Final Precursor Analysis

Accident Sequence Precursor Program --- Office of Nuclear Regulatory Research

Fitzpatrick	Automatic Reactor Trip and Loss of Offsite Power Due to the August 14, 2003, Transmission Grid Blackout	
Event Date	8/14/2003	LER: 333/03-001
		CCDP ¹ = 4×10^{-6}

December 17, 2004

Figure 2: Fitzpatrick SBO event tree with dominant sequence highlighted.

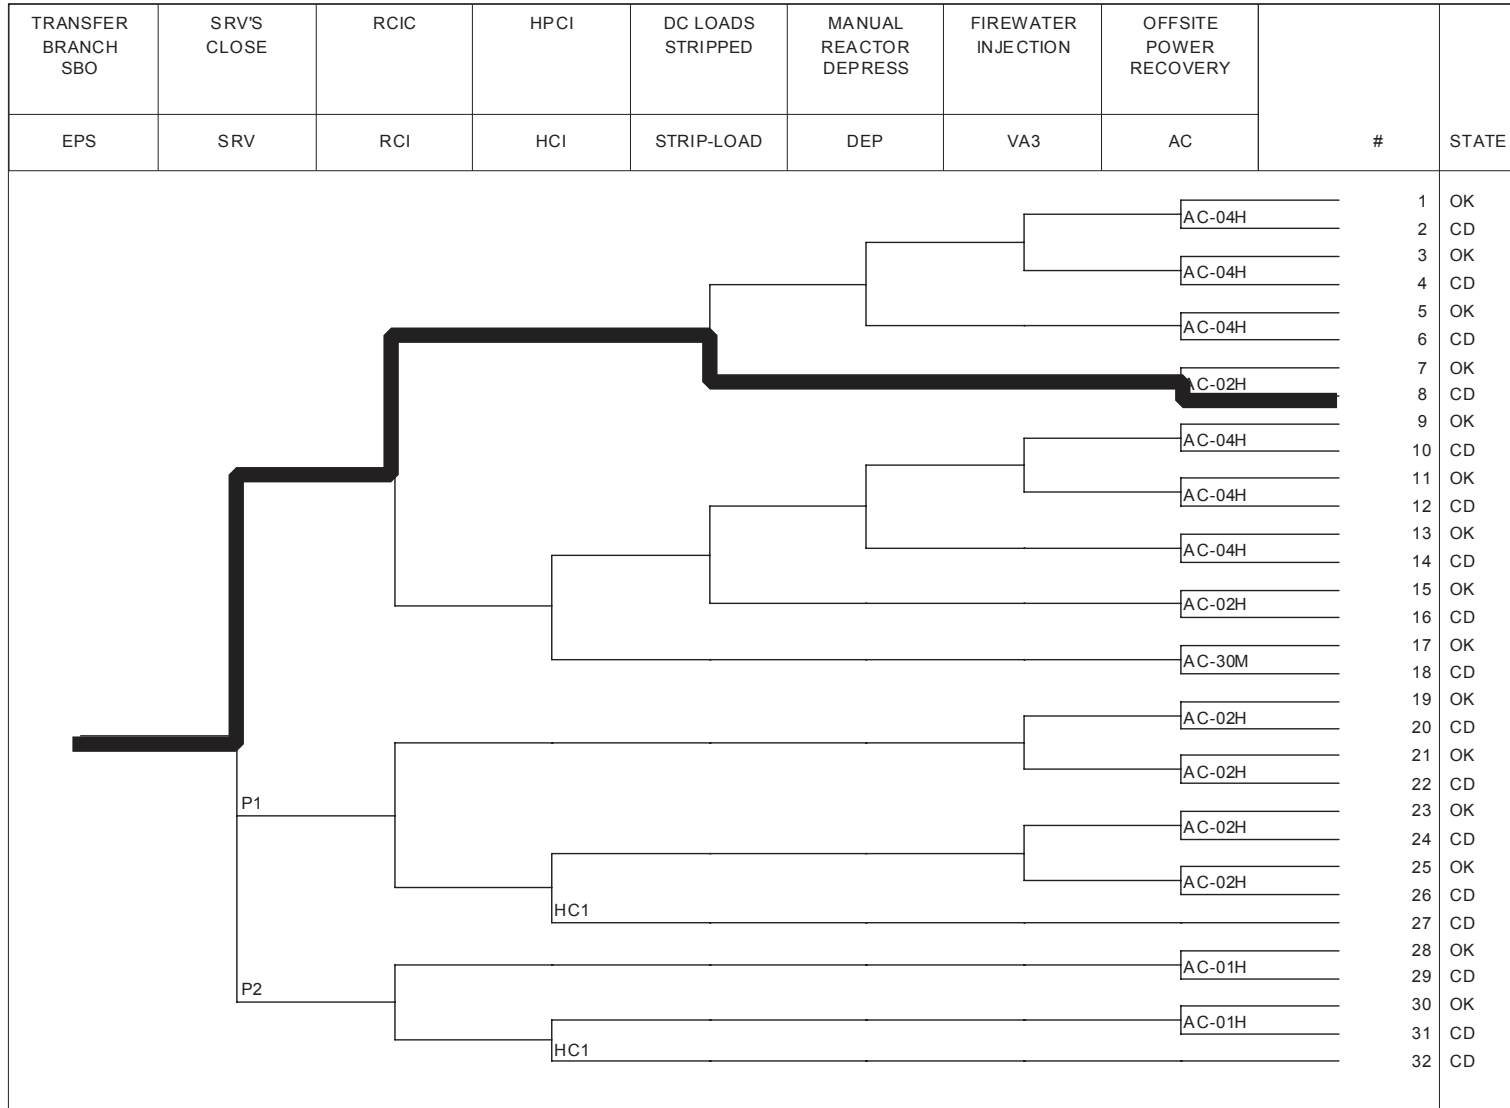
“The crosstie between the firewater system and EDG jacket coolers can be credited in accident sequence cutsets which involve failures of components in the ESW system with successful closure of 46MOV-102A/B. As an example, for the dominant core damage sequence LOOP/SBO sequence 47-02, fire water cross-tie recovery can be credited for cutsets of CCDP $6.5E-7$ and below.”

Response: The firewater backup is included for EDG cooling. For sequence 47-02, each cut set in the GEM report with CCDP below $6.5E-7$ contains the event FWS-XHE-ERROR. FWS-XHE-ERROR is defined as “operator fails to start/control firewater injection/cooling,” which is used for alternate injection and for EDG jacket cooling. The probability of FWS-XHE-ERROR is $6.0E-2$.
